# January 2024 V10 Workspace Changes

# December 2023 V10 Workspace Changes

# November 2023 V10 Workspace Changes

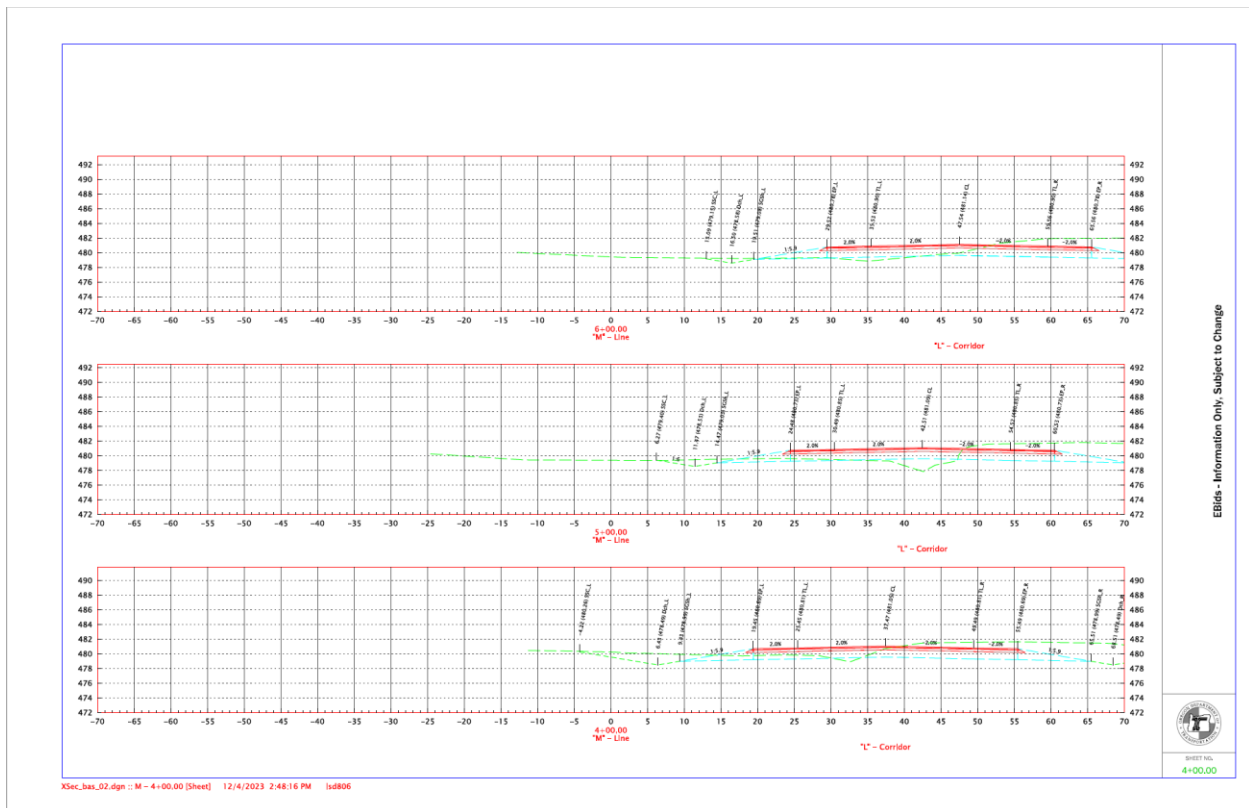
We received a corrected **Cross Section Grade Book From Centerline** report from Bentley and have provided that in the Civil Report Browser in the Custom folder. *CrossSectionGradebookfromCL.xml* in the Evaluation folder displays decimal slopes on the right side, while the **corrected report in the Custom folder** displays slopes in percent on both sides of the centerline.
